**(C) AMENDMENTS TO THE DRAWINGS**

#### **(D) REMARKS**

FIG. 1

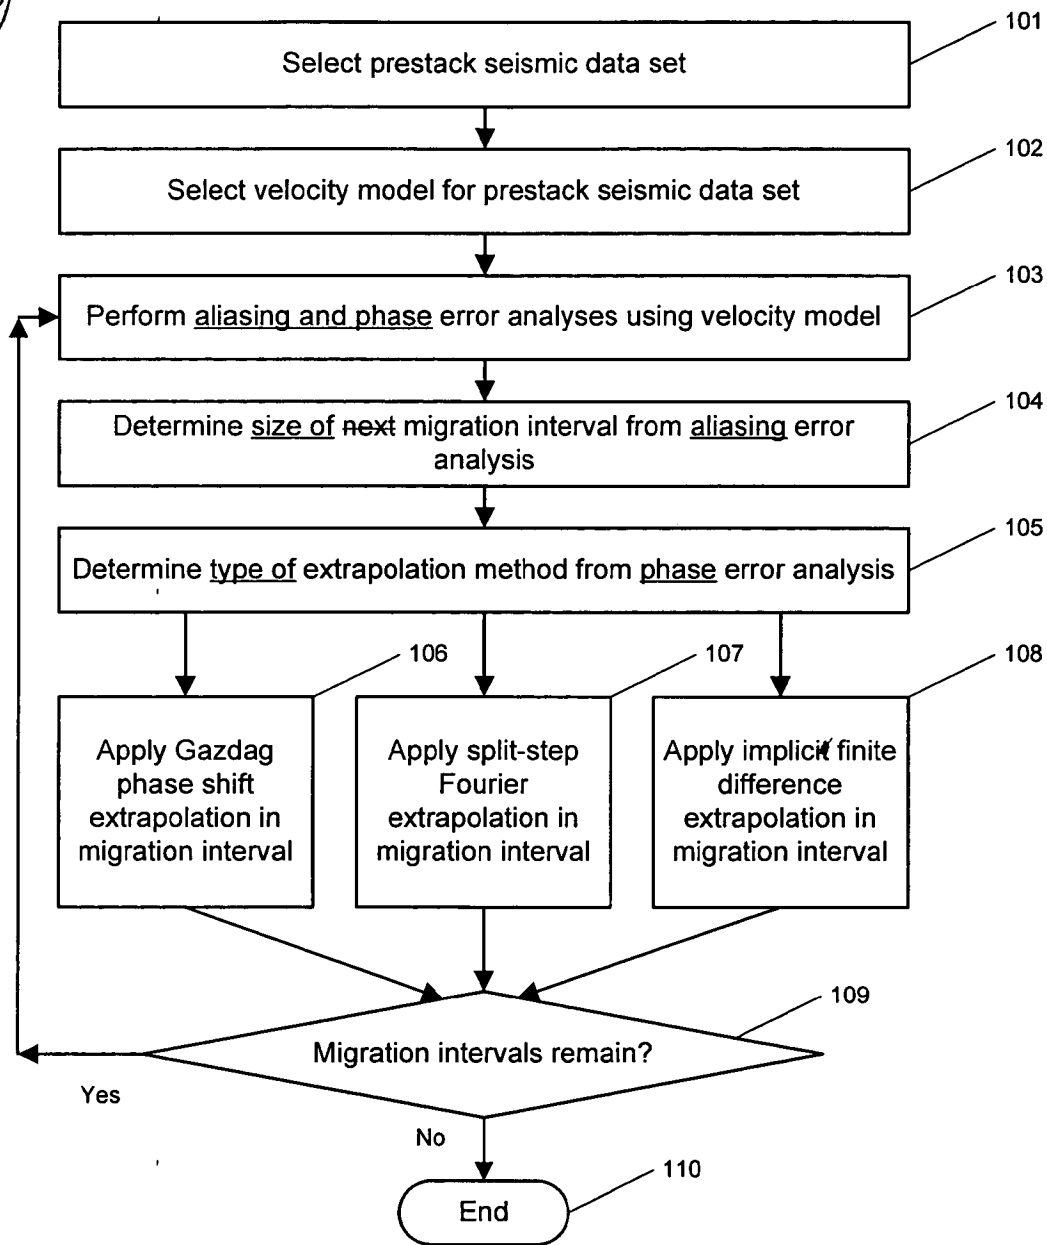
Sheets 1 and 3 of the drawings are amended to correct errors in the flowcharts contained in FIGS. 1, 3, and 4. In particular, the flowcharts in FIGS. 1 and 3 are amended to conform to the description of the flowcharts given in the specification, as discussed in further detail below, while FIG. 4 is cancelled.

With reference to amended FIG. 1, the text in steps 103, 104 and 105 of the flowchart are amended to conform to the descriptions of these steps given in the specification in paragraphs [0030], [0031], and [0031], respectively. Thus no new matter is added, since the amended text only contains material already present in the specification as originally filed.
